UNITED STATES PATENT AND TRADEMARK OFFICE

APPLICATION NO.	FILING DATE	FIRST NAMED INVENTOR	ATTORNEY DOCKET NO.	CONFIRMATION NO.
09/476,521	01/03/2000	Herbert Gropp	RUM212	7964

Office Action Summary

Fig.3

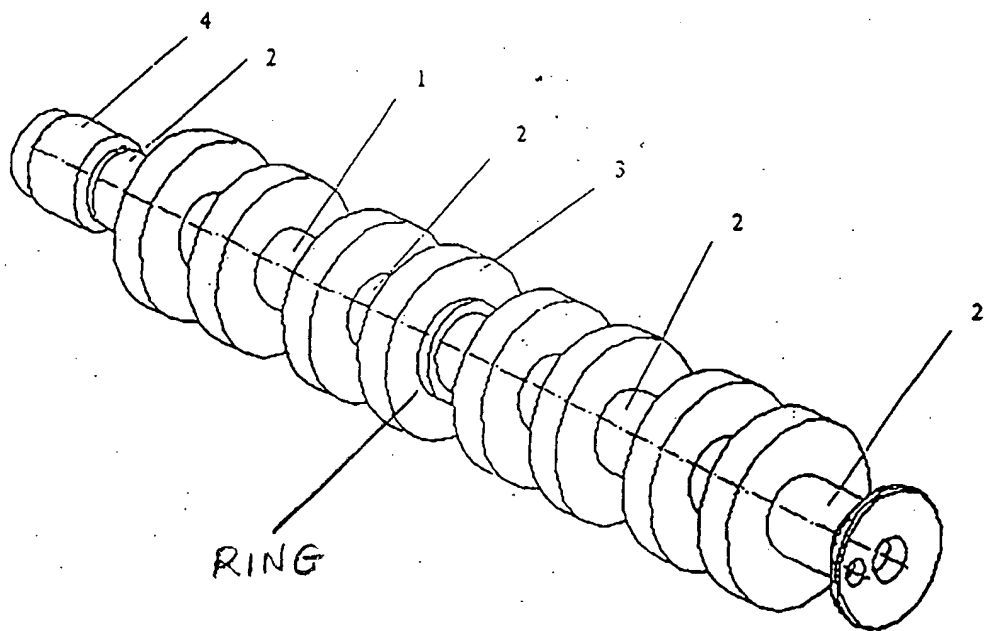
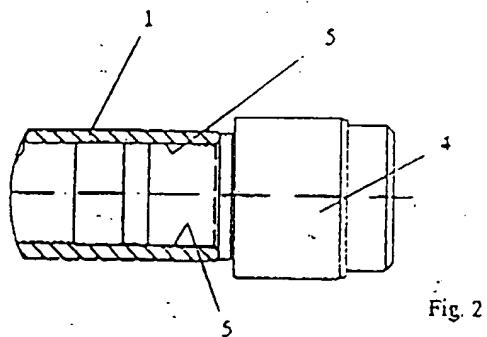
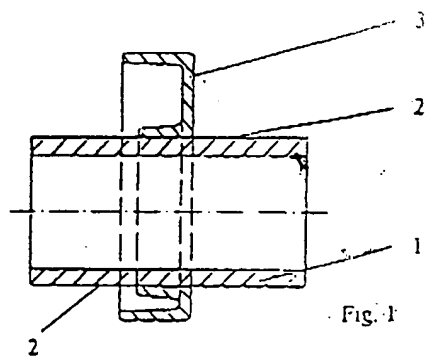
(b) new Fig. 3 introduces new matter, such as, the deletion of a ring (unnumbered, see Exhibit attached). The original Fig. 3 shows the ring located adjacent to the cam 3, however, new

Fig. 3 now does not show such ring. See *Twin Disc v. United States*, 231 USPQ 417, 435 (US Cls. Ct. 1986)(new matter by deletion).
